AGENDA

January 13, 2021 9:30 a.m.

(a) Land Development Code

The attached document “Addendum of Recommended Changes” dated January 5, 2021 includes changes suggested from public input and interested parties (letters and E-comments) as well as suggestions by the Design Review Board, Planning and Zoning Board, and staff.

TABLE 5-403.B.3: TREE AND PALM PLANT MATERIAL STANDARDS

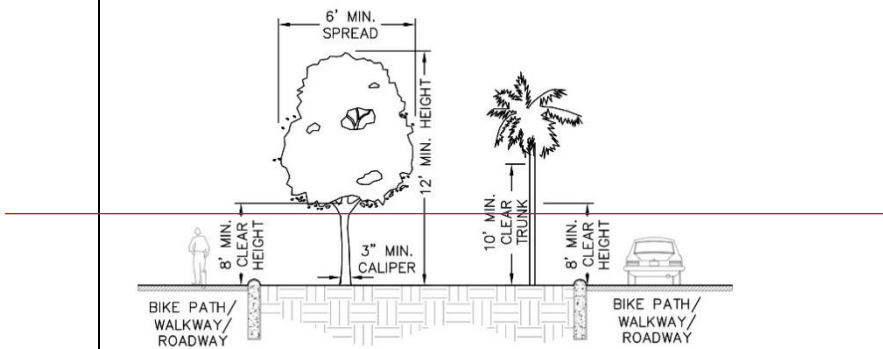
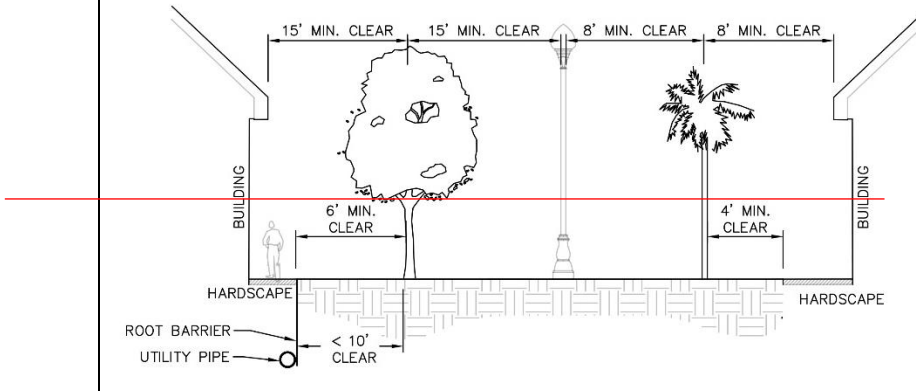
5-403.B.3: DRB suggested that plant separation requirements should not be dictated by simple numeric standards, which limits a design and is arbitrary, allow for building arrangement to dictate plant placement.

Sec. 5-403.B.3. Trees and Palms

All required trees shall be a minimum 12-foot in height measured from the adjacent grade of the development site, with a ~~six~~five-foot spread and ~~threetwo~~and one half-inch caliper and forty-five gallon container size or field grown at the time of planting. Palms shall have a minimum of ten feet of clear trunk at planting. ~~Trees adjacent to walkways, bike paths, and rights-of-way shall be maintained with eight feet of clear trunk. Trees shall provide 15-foot clearance from light poles and buildings; palms shall provide an eight-foot clearance. Trees shall provide a six-foot clearance from hardscapes; palms shall provide a four-foot clearance.~~ Root barriers are required for all trees planted within ten feet of hardscape or utilities. See Table 5-403.B.3: Tree and Palm Plant Material Standards.

| Standard | Trees | Palms |
|---|--|----------------------------|
| Height, spread, caliper at planting | 12 feet in height, 6 5-foot spread, 3 2.5-inch caliper | 10 feet of clear trunk |

50. A.1 Four and Six-Lane Arterial Roads

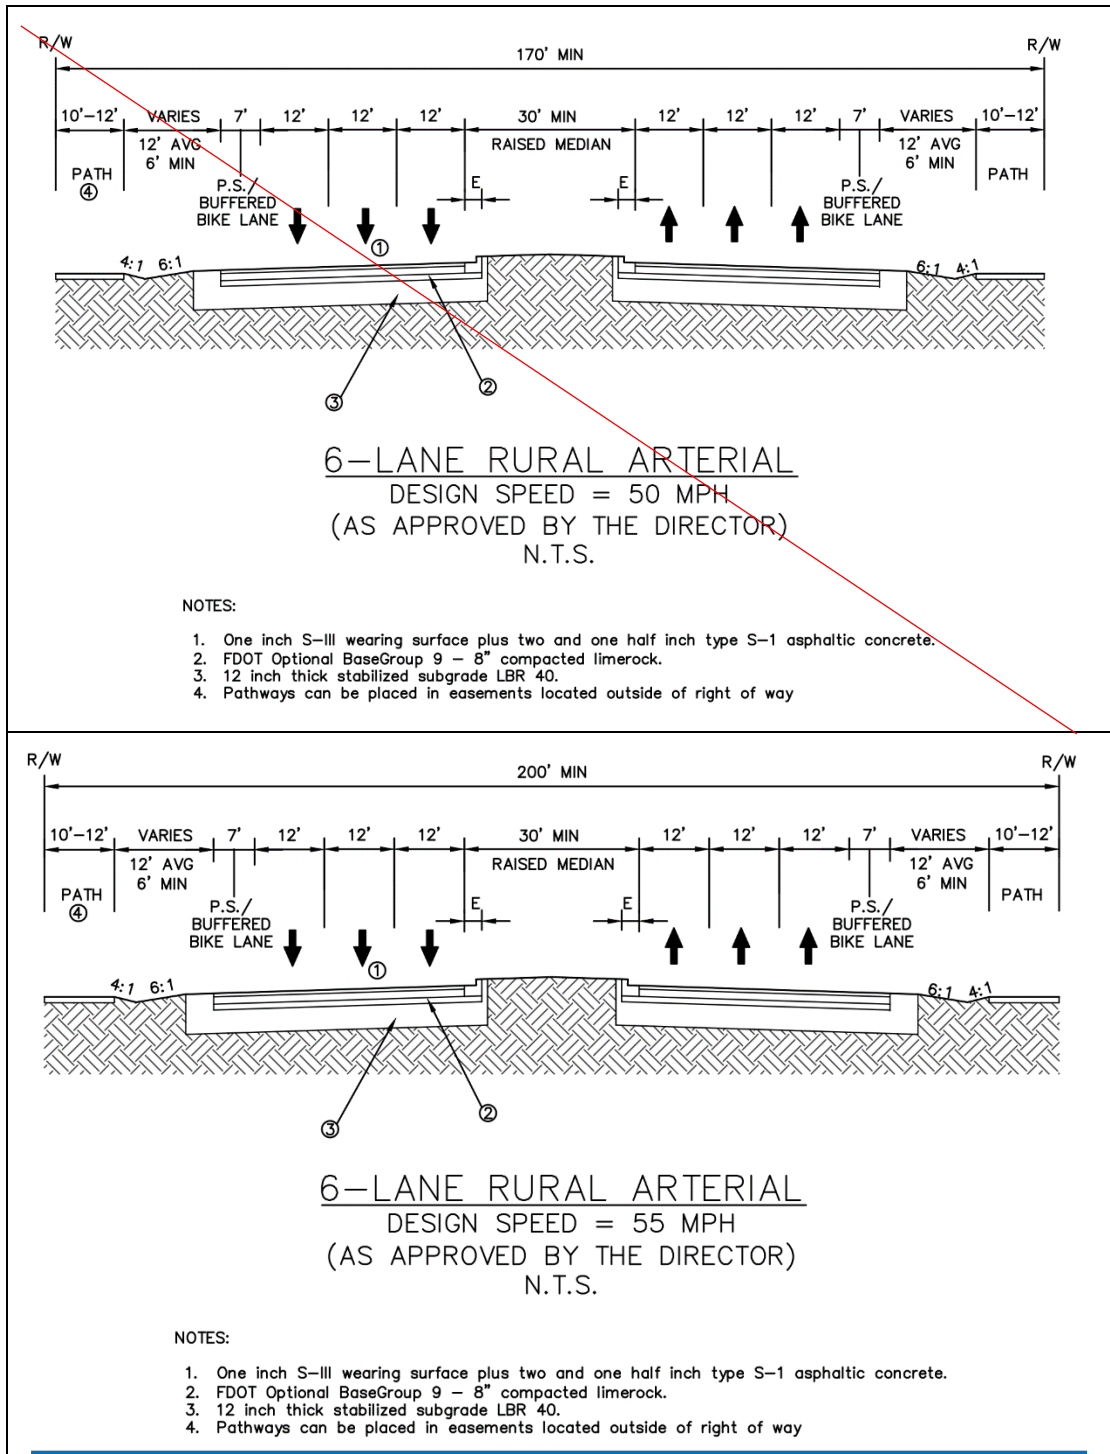
Changes to Appendix D on the following pages are technical in nature and recommended by Village staff
